SERVICE BULLETIN

NO. 1216B

SUBJECT: AILERON RIB INSPECTION

REASON FOR REVISION: To provide a means of more easily visually identifying ailerons that have been replaced or reworked to eliminate the recurring inspection requirements mandated by this Service Bulletin.

Figure 3
Outboard Aileron Hinge Nose Rib Installed With Nut plate

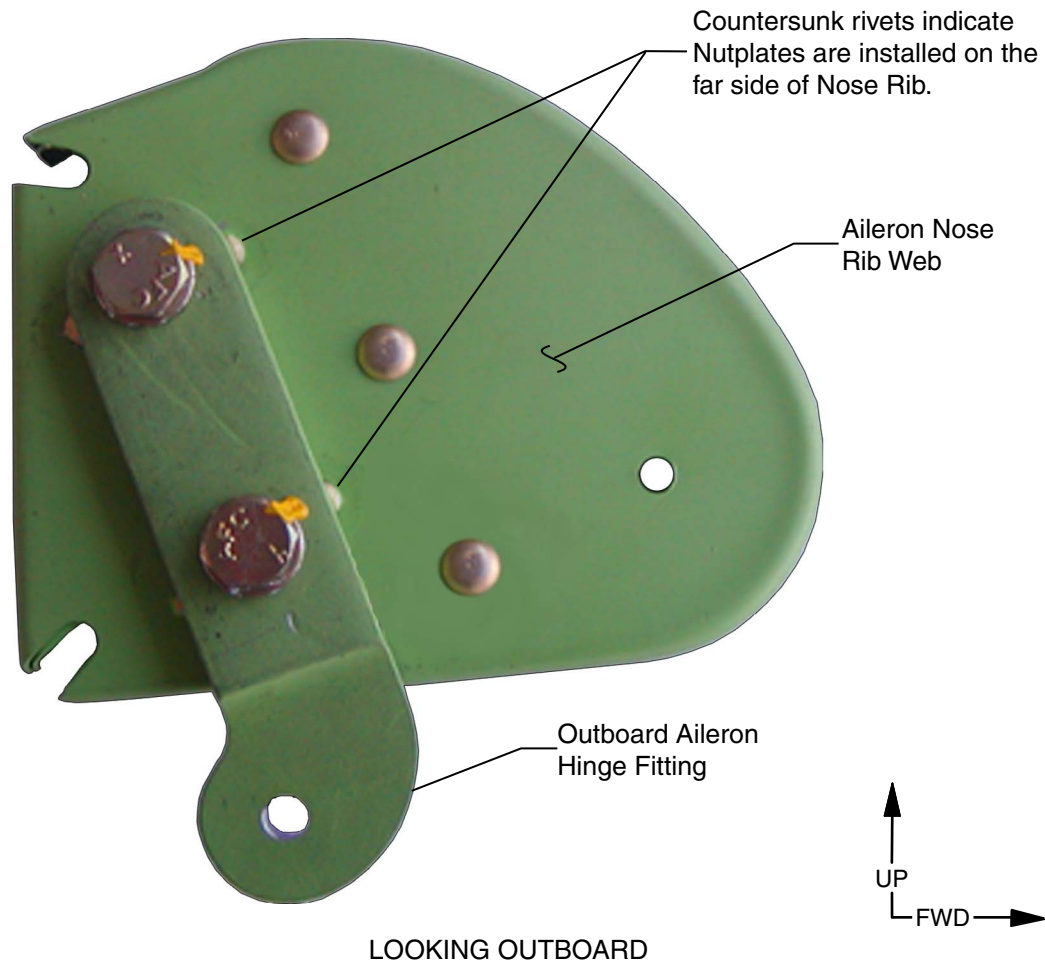
- If bolt heads are visible, carefully examine the adjacent area of the nose rib web for the presence of countersunk head rivets, as shown in Figure 3. These rivets indicate that a nut plate has been installed on the outboard side (hidden side) of the nose rib web, as shown in Figure 4. These rivets may be hidden by paint. If in doubt, use a borescope to examine the far side of the nose rib web for the presence of nut plates.

NOTE: Nutplate configuration may vary. Any configuration with nutplates at this location requires a recurring inspection.

Figure 5
Inspection Area

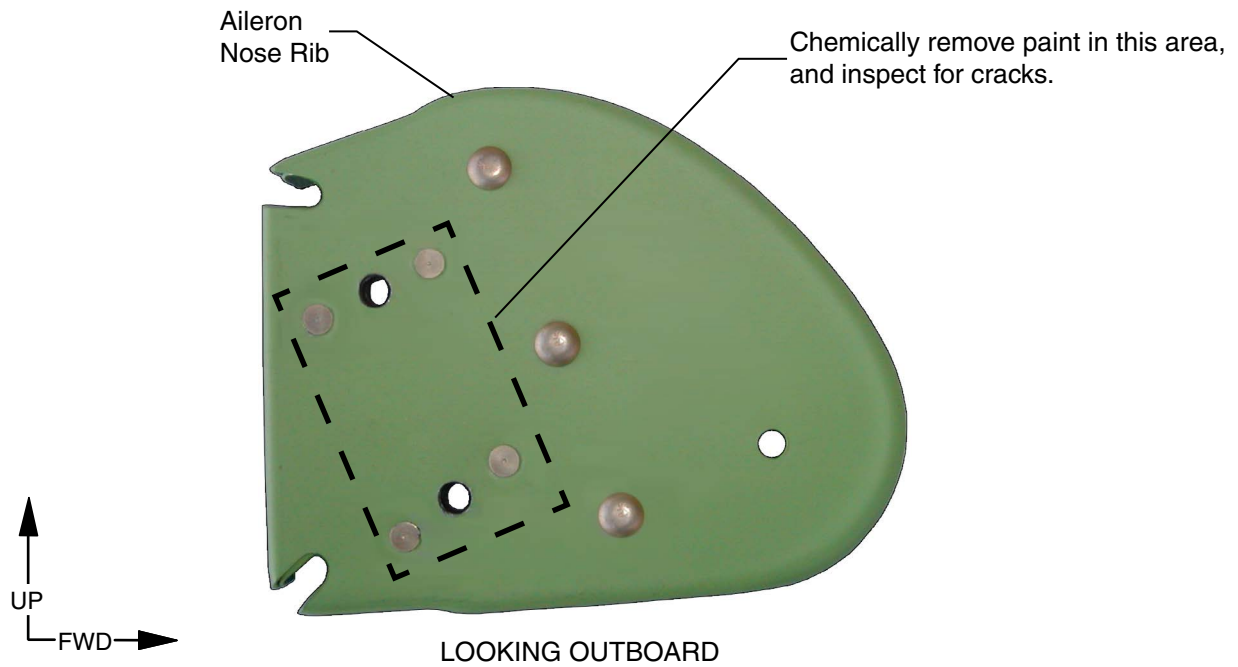
- b. Unbolt the outboard aileron hinge fitting. Hardware in good condition may be reused.
- c. Remove paint from the nose rib, in the areas identified in Figure 5. (Use Cee-Bee A-202 paint stripper or equivalent).

NOTE: Paint must be removed using chemical processes only. The use of abrasives or other mechanical methods to remove the paint will hide the existence of any cracks, making an accurate inspection impossible. Use isopropyl alcohol to wipe clean the area of the nose rib where paint was removed. See Figure 5.

- d. Perform fluorescent penetrant inspection on the area identified in Figure 5, using procedures described in FAA Advisory Circular AC 43.13-1B.
 - If a crack is detected, proceed to **Part III** Terminating Action.
 - If no crack is detected during the inspection, wipe area of inspection clean with isopropyl alcohol. Apply primer to nose rib in area where paint was removed for inspection using MIL-PRF-85582D Type I Class C2 primer, ANAC 10P8-10 Fluid Resistant Epoxy primer, or any compatible epoxy primer. Apply a compatible top coat of paint such as DuPont Imron, color to match adjacent paint.
- e. Reinstall hinge fitting.
- f. Reinstall aileron.
- g. Proceed to **Part IV** Documentation of Compliance.

Figure 6

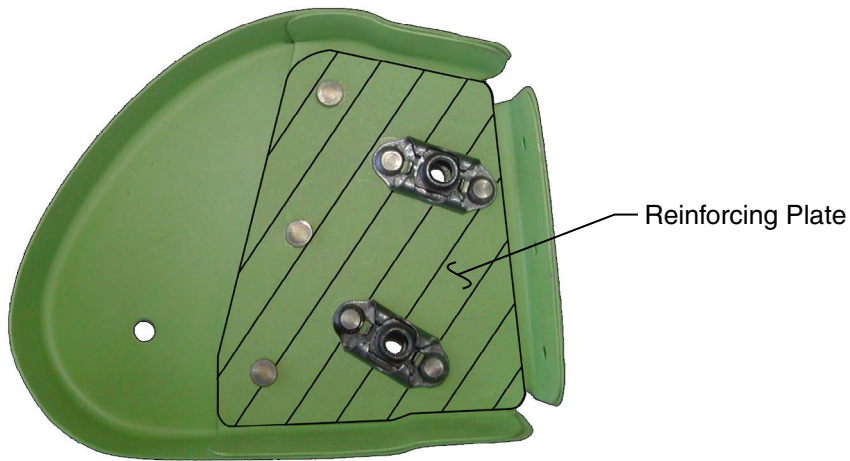
NOTE: New, replacement Ailerons, Piper P/N 38650-007 (right side) and P/N 38650-008 (left side) and new replacement Outboard Aileron Nose Ribs, Piper P/N 86398-009 (right side) and P/N 86398-008 (left side) feature a reinforcing plate installed between the rib doubler and the nutplates. This reinforcing plate can be identified by carefully examining the aileron nose rib from either the inside or outside surfaces. This reinforcing plate is designated by the cross-hatched areas shown in Figures 6 and 7. Note that figures 3, 4, and 5 show aileron nose ribs without a reinforcing plate. Aileron nose ribs with the reinforcing plate do not require a recurring inspection.
